RE: R&R Trucking - 7021 Huseman Place SW

**Grading and Drainage Plan**

**Stamp Date: 3/31/17**

Hydrology File: M10D016I

# GRADING AND DRAINAGE PLAN

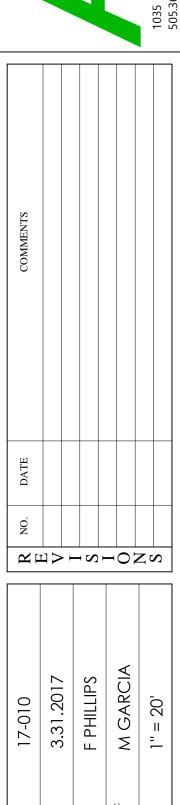
1. There appears to be existing asphalt on the site. Please show it if it exists. This may affect the proposed grading.

2. There appears to be an existing driveway. Please show this if it exists.

3. Under the Drainage Calculations – Existing Conditions, This site appears to have been reworked over the past several years based on historical imagery. If this is the case, than the site is not Type "A" but Type "C". Also as mentioned in item #1, the existing asphalt is Type "D". Also the existing carport and mobile home are Type "D". This should just change the existing runoff.

4. It appears that the majority of the runoff from the proposed building outfalls towards the SE corner of the property before entering the Huseman Place curb drainage system. Please add the first flush basin in this area for the runoff.
